State Significant Development Further Information and Response to Submissions

161 Sussex Street Redevelopment

Submitted to Department of Planning and Infrastructure
On Behalf of GL investment Co Pty Ltd GL No 1 Trust

February 2013 ■ 11030

Figure 1 – New western elevation and roof structure

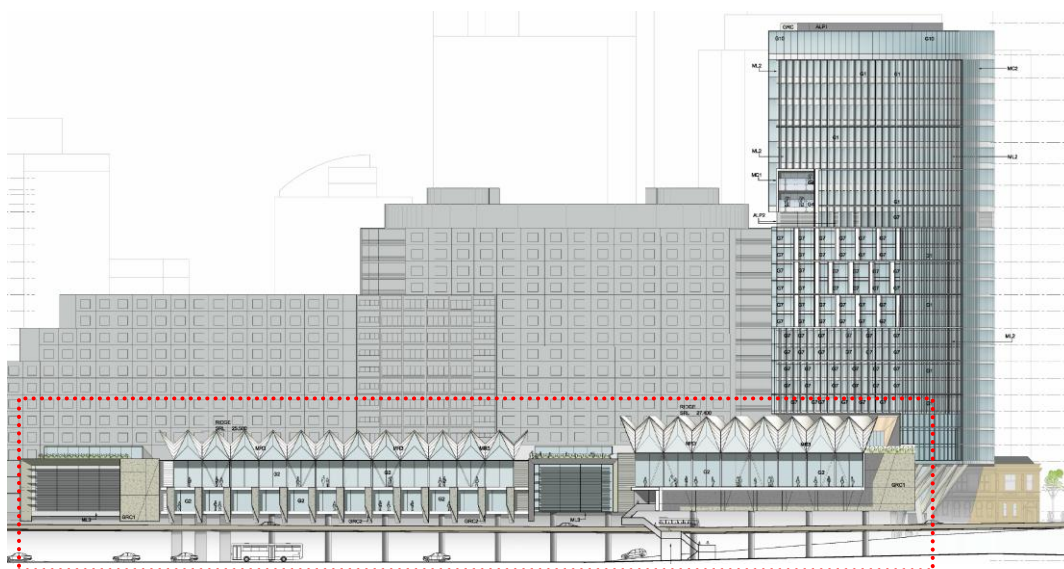
Further design work has been undertaken to produce a western elevation that presents a more visually interesting and varied facade to Darling Harbour (refer **Figure 1**). As shown in updated Architectural Plans prepared by Cox Richardson Architects (**Appendix B**) the western elevation is now divided into three distinct expressions, these being the southern main hall, the north function space and lower volume pre-function spaces. The design and location above the roadway mean that the podium will be visually read as an integrated piece of infrastructure design sitting over the freeway structure.

The roof structure for this part of the building has also been comprehensively redesigned and now presents as a folded roof element that positively adds to a distinct architectural expression when viewed from Darling Harbour. The new roof design highlights the lower levels of the building and effectively breaks down its mass when viewed from the west. The pitched roof elements also make a subtle contemporary reference to the existing roof peaks of the heritage listed Corn Exchange.

The roof of the convention and function area has been comprehensively redesigned to provide a more distinctive and varied roof form that adds to the visual interest of the building and breaks up the horizontality of the of the low rise podium extension. Key features of the revised design include:

- Use of a distinctive, dynamic folded plate roof structure that draws attention to the base of the building and effectively breaks down its visual mass when viewed from Darling Harbour.

- Pitched roof elements that make a subtle contemporary reference to the traditional pitched roof forms such as that of the heritage listed Corn Exchange.
- Varied height in the roof form across the entire length of the western elevation, including variations in the height and design of the northern and southern roof components.
- Use of landscaping along the roof terraces to soften and visually break-up the roof form.

Overall the revised design represents a substantial improvement on that previously proposed and once complete will make a significant positive contribution to the appearance of the city when viewed from Darling Harbour (refer **Figure 1** and **Appendix B**).

Figure 3 – Proposed building separation (Source: Cox Richardson Architects)

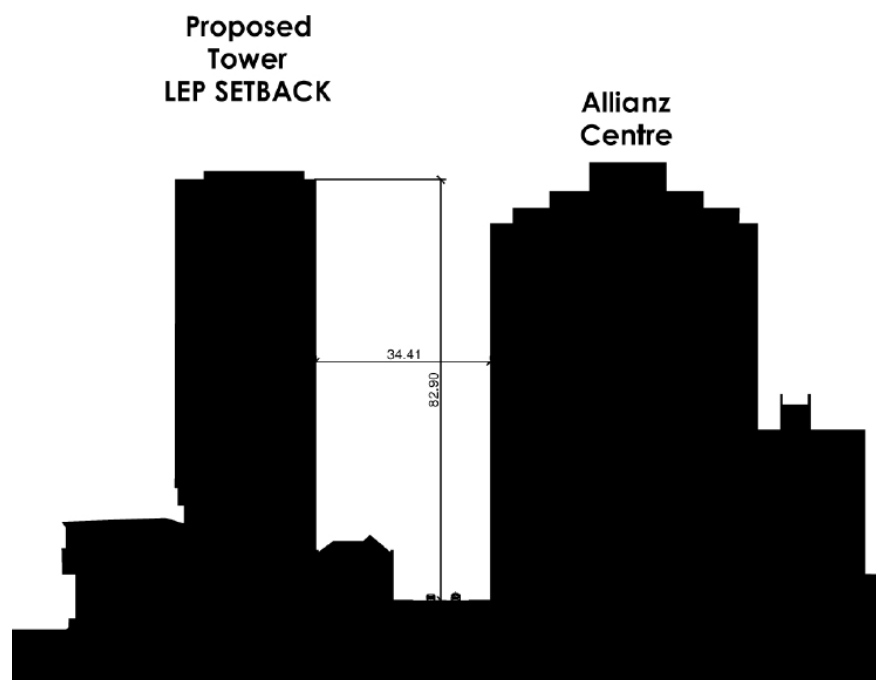
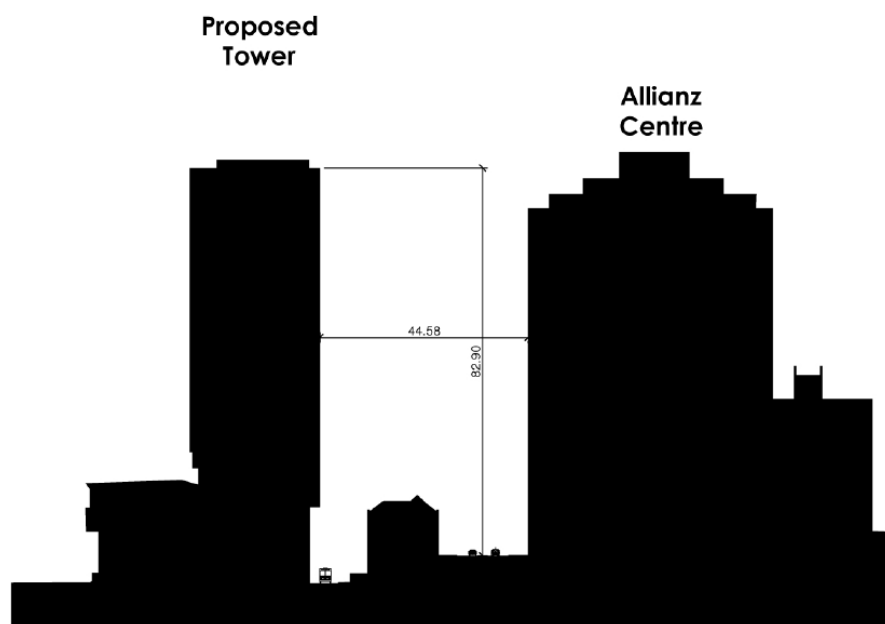
- The proposed tower has been significantly set back from Sussex Street, ensuring a building separation distance of 44.58m, being well above the 34.41m required by City of Sydney planning controls (refer **Figures 2 and 3**). Once again the increased setback supports a more open view corridor to Cockle Bay.

Figure 5 – Amended building podium (Source: Cox Richardson Architects)

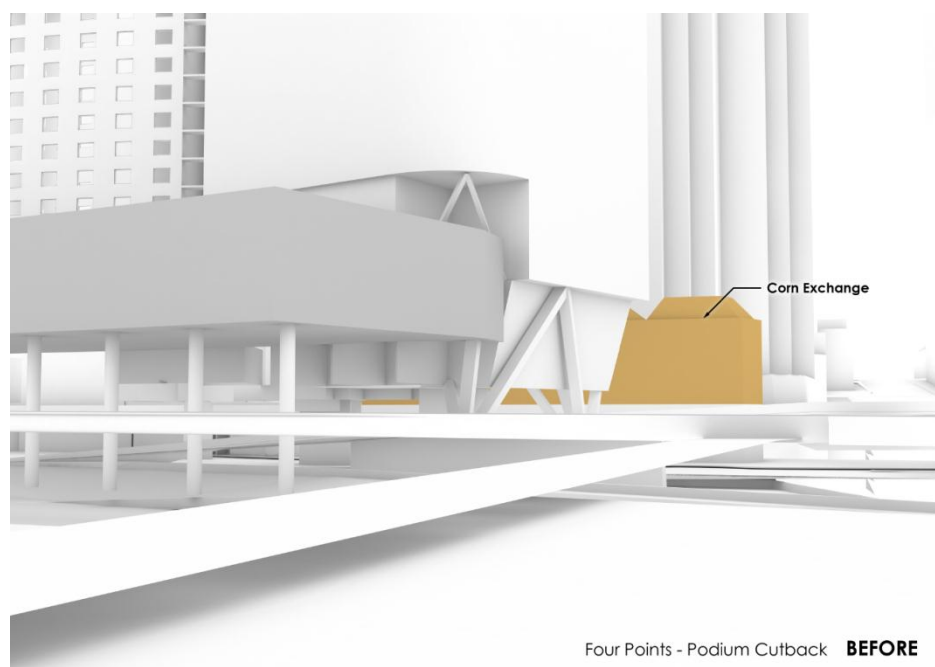
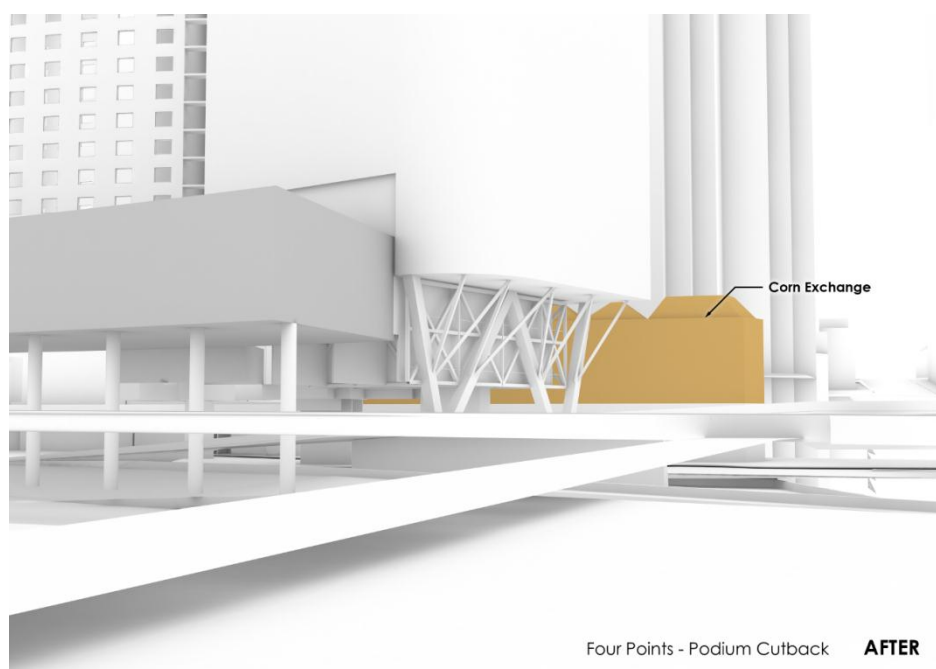
- b) Options for improving views from the Corn Exchange to the Pyrmont Bridge and to Darling Harbour public domain by remodelling the mass of the proposed tower below level one (partially glazed) and potentially refining the structural supports, whilst maintaining references to the Corn Exchange parapet.

The design of the proposed tower has been amended to facilitate improved sight lines and views from the Corn Exchange to the Pymont Bridge and Darling Harbour. Specifically the alignment of the building's ground and level one facade facing Market Street have been recessed and redesigned, which as shown in **Figures 4** and **5** will help open up views to and from Corn Exchange Building to Pymont Bridge and vice-versa. This design change together with the removal of the existing tress on site will reinstate the historical visual relationship between the two heritage structures. For further details refer to the revised architectural plans and diagrams (**Appendices B** and **C**) prepared by Cox Richardson Architects.

Figure 6 – Revised Wharf Lane design (Source: Cox Richardson Architects)

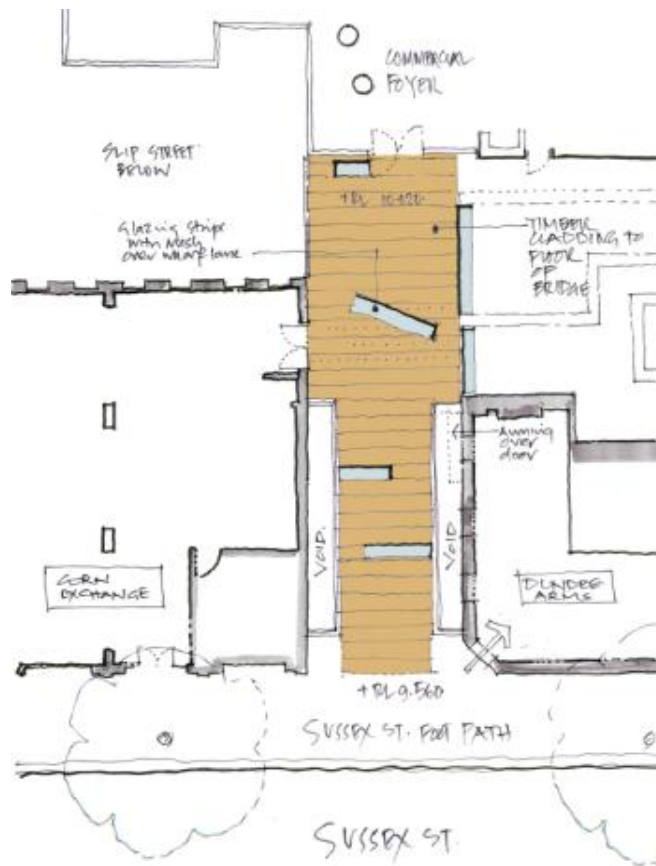
The proposed works to Wharf Lane have been redesigned to provide an outcome that is more sympathetic to, and which highlights the original heritage fabric of the area. A bridge structure is now provided in the original alignment of Wharf Lane with two openings with glazed balustrades provided on both the northern and southern edges of the bridge adjacent to the heritage buildings (refer **Figures 6 and 7**). These voids on either side of the bridge will reinforce the concept and feel of the bridge structure and will allow for views to the original heritage fabric of Wharf Lane below.

Timber floor cladding will be used for the full extent of bridge to provide a softer more heritage feel to the structure. Glazed/mesh openings on the ground plane will create points of interest within the structure and will allow for views of the original Wharf lane below. One of these openings is also proposed to be positioned on a diagonal angle to reflect the alignment and allow for clear views of the original sandstone wall of Wharf Lane on Slip Street.

The awning to the commercial tower entrance has been pulled back to ensure it no longer interferes with the balcony or setting of the Dundee Arms and the Corn Exchange. This revised design therefore now supports wider unobstructed views of Wharf Lane elevations of both listed buildings.

Figure 8 – Accessible route between existing and proposed development (Source: Cox Richardson Architects)

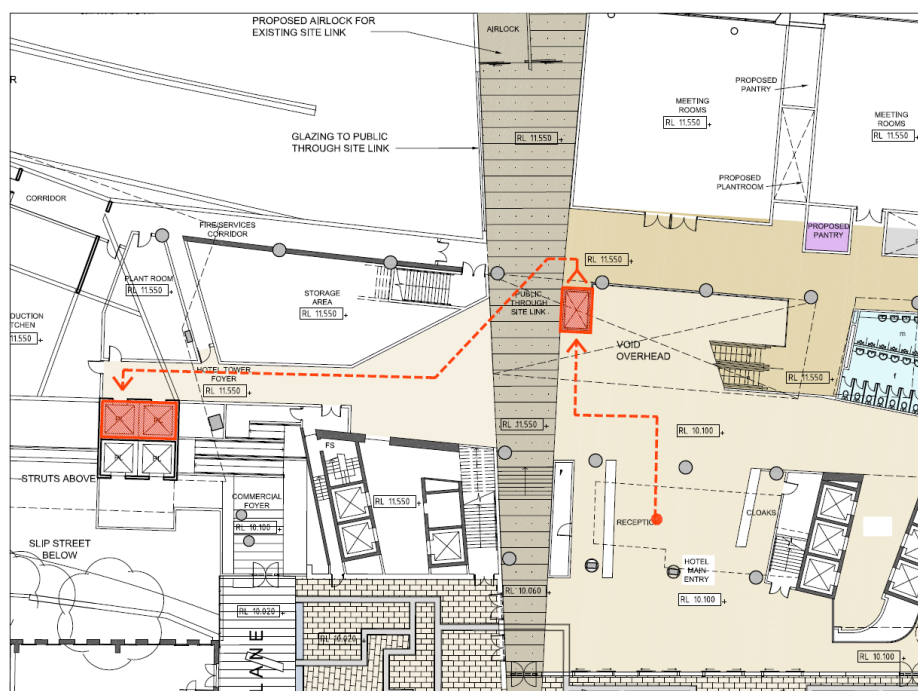
Glazing is proposed across the majority of the link's external southern wall allowing for expansive views across the Western Distributor to Pyrmont Bridge and Cockle Bay. The use of glazing will also provide abundant natural light and maximise the sense of amenity and safety.

The through site link is split into two sections by a single short set of stairs incorporated into the design to account for the 1450mm level change between the Sussex Street and Wheat Street stairs. A lift providing an accessible path is located within the hotel lobby, ensuring an accessible route is provided between the hotel and through site link, whilst also providing access between the lobby and the new hotel component (refer **Figure 8** and **Appendix C**). It is noted that an alternative option was considered involving a 20m long ramp to accommodate the 1.450m level change. Whilst considered a preferred design solution for hotel patron access, the constraints imposed by the location of the existing hotel lift cores prohibits a ramp solution from working within this part of the building.

Figure 9 – Through site link landing area between Wheat Road and King Street overpass (Source: Cox Richardson Architects)

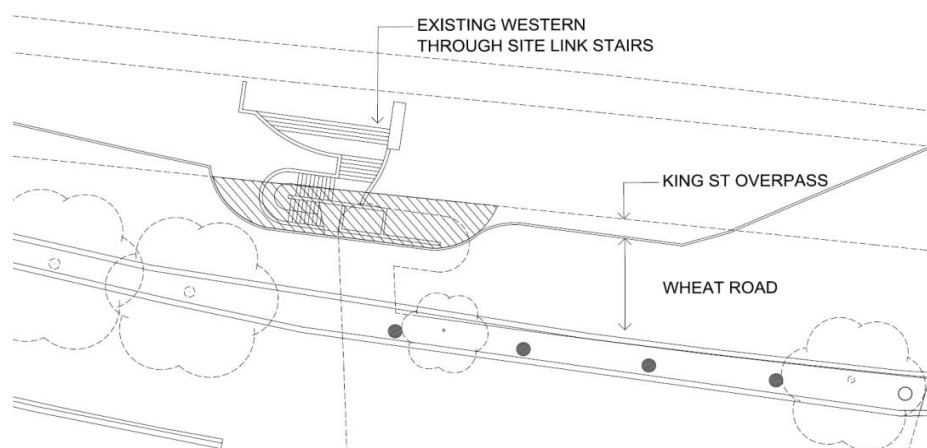
Investigations were also undertaken into the possibility of a lift being provided at the western Wheat Street end of the link adjacent to the existing stairs, however these investigation concluded that a lift could not be accommodated due to the location of the King Street overpass and the constrained footprint available (refer **Figure 9**).

Figure 11 – Diagram showing potential walkway, stair and lift location (Source: Cox Richardson Architects)

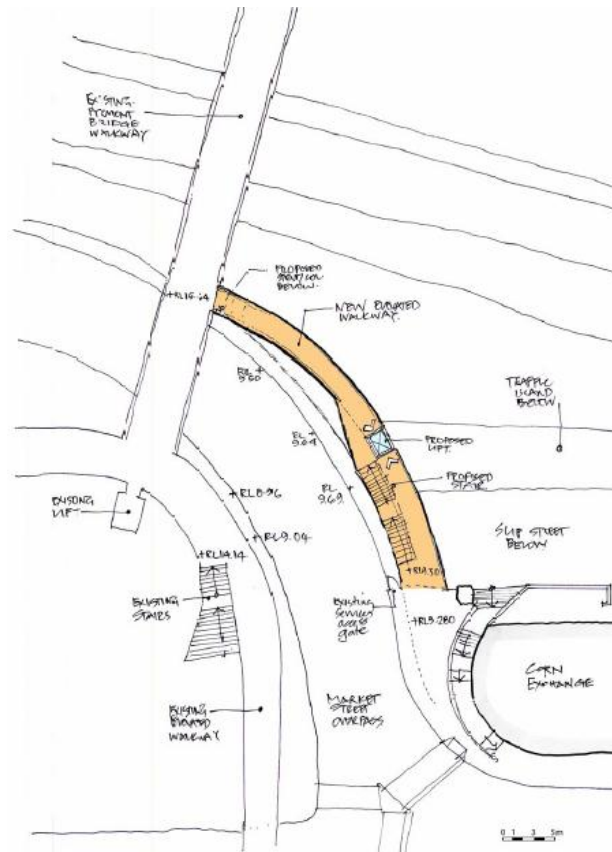
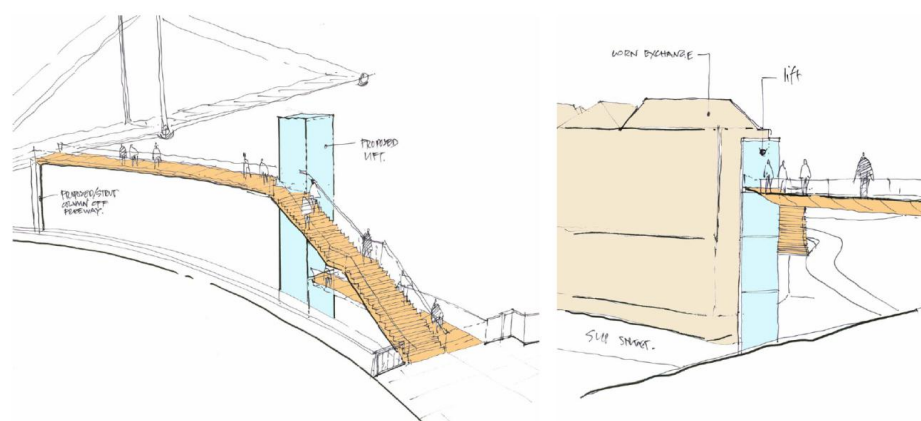
- d) Pedestrian connection
 - Provide concept design options to connect to the Market Street/Pymont Bridge walkway to test the feasibility of establishing a pedestrian connection following the decommissioning of the monorail. Options should include a design concept for an access ramp connecting the former Pymont Bridge abutment adjacent to the southern end of the Corn Exchange to the Darling Park bridge following the curved alignment of the Market Street off-ramp (below). Provide an estimate for the cost of these options.

From a theoretical design point, a lift structure could be located on this island with a stair spanning from the pedestrian footway at the southern edge of the Corn

Exchange onto the lift structure. An elevated bridge would then connect the stair and lift landing area with the Darling Walk bridge supported by a column onto the Market Street overpass structure below. This design option is shown in **Figures 11** and **12** below.

Feasibility of the above configuration is however subject to undertaking detailed analysis of in-ground services locations and the structural capacity of the Market Street overpass to support the column at the junction with Darling Walk bridge. Initial investigation by our structural engineers (Aurecon) has confirmed that the Darling Walk bridge structure would not have sufficient load bearing capacity to support the new bridge connection at the mid span position.
